Attachment I to IPN-88-015  
Proposed Technical Specifications Related To  
Movable Incore Neutron Detector Guide Thimbles

New York Power Authority  
Indian Point 3 Nuclear Power Plant  
Docket No. 50-286  
DPR-64

Attachment II to IPN-88-015  
Safety Evaluation of Proposed Technical Specification  
Related to Movable Incore Neutron Detectors.

Figure 3.10-6

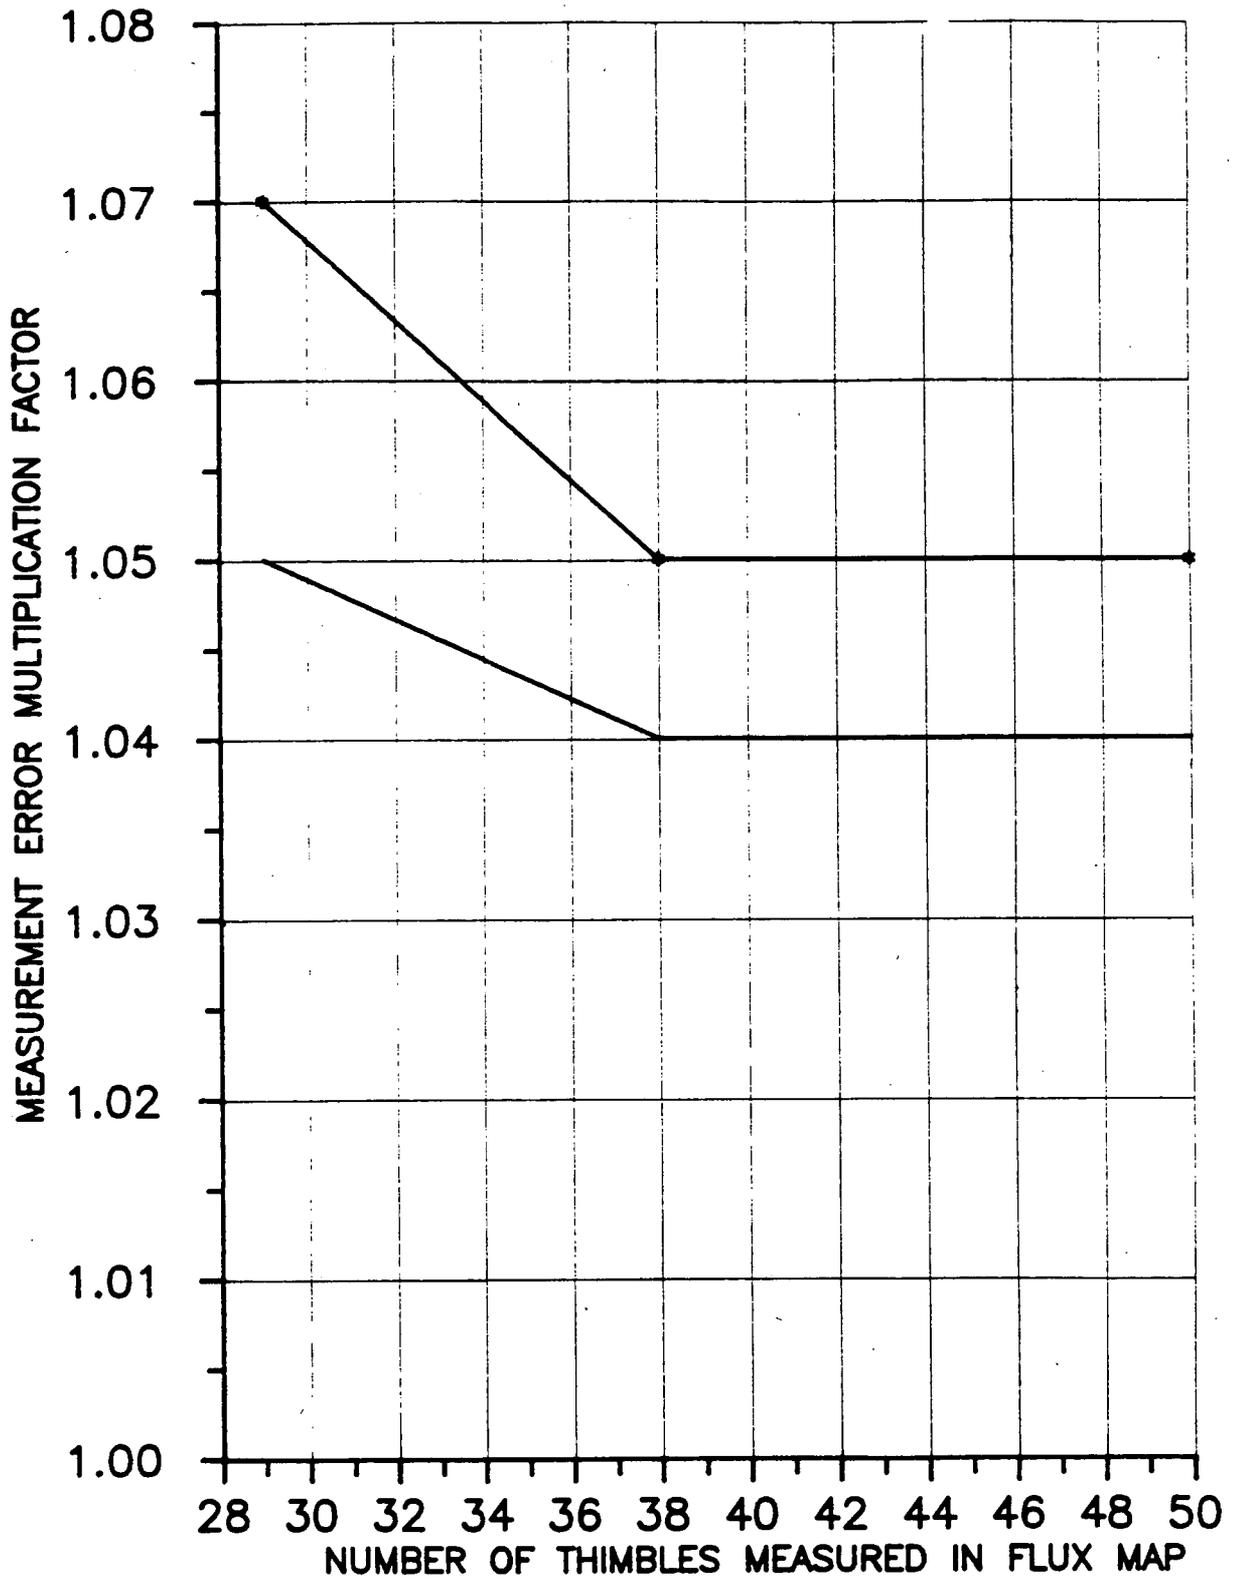
- 3.10.2.2.1 The measurement of total peaking factor  $F_Q^{Meas}$ , shall be increased by three percent to account for manufacturing tolerances and further increased by five percent to account for measurement error when 38 or more thimbles are utilized in the generation of the full core flux map. When less than 38 thimbles are utilized, the measurement error factor increases linearly from five to seven percent at 29 thimbles operable. Figure 3.10-6 provides the measurement error factor as a function of available thimbles.

- 3.10.2.2.2 The measurement of enthalpy rise hot channel factor,  $F_{\Delta H}^{NH}$ , shall be increased by four percent to account for measurement error when 38 or more thimbles are utilized in the generation of the full core flux map. When less than 38 thimbles are utilized, the measurement error factor increases linearly from four to five percent at 29 thimbles operable. Figure 3.10-6 provides the measurement error factor as a function of available thimbles. If either measured hot channel factor exceeds its limit specified under Item 3.10.2.1, the reactor power and high neutron flux trip setpoint shall be reduced so as not to exceed a fraction of rated power equal to the  $F_Q$  or  $F_{\Delta H}^{NH}$  limit to measured value, whichever is less. If subsequent in-core mapping cannot, within a 24-hour period, demonstrate that the hot channel factors are met, the reactor shall be brought to a hot shutdown condition with return to power authorized only for the purpose of physics testing.

When an  $F_Q$  measurement is taken, both experimental error and manufacturing tolerance must be allowed for. As depicted in Figure 3.10-6, five to seven percent is the appropriate

allowance for a full core map taken with the movable incore detector flux mapping system depending on the number of thimbles utilized during the generation of the full core flux map and three percent is the appropriate allowance for manufacturing tolerance.

In the specified limit  $F_{\Delta H}^{NH}$  there is an eight percent allowance for uncertainties which means that normal operation of the core is expected to result in  $F_{\Delta H}^{NH}$  1.55/1.08. The logic behind the larger uncertainty in this case is that (a) normal (e.g. rod misalignment) affect  $F_{\Delta H}^{NH}$ , in most cases without necessarily affecting  $F_Q$ , (b) the operator has a direct influence on  $F_Q$  through movement of rods, and can limit it to the desired value, he has no direct control over  $F_{\Delta H}^{NH}$  (c) an error in the predictions for radial power shape, which may be detected during startup physics tests can be compensated for in  $F_Q$  by tighter axial control, but compensation for  $F_{\Delta H}^{NH}$  is less readily available. When a measurement of  $F_{\Delta H}^{NH}$  is taken, experimental error must be allowed for and 4 percent is the appropriate allowance for a full core map taken with the movable incore detector flux mapping system with 38 or more thimbles available. As shown in Figure 3.10-6, the measurement allowances will be linearly increased from 4 percent to 5 percent at 29 thimbles available.
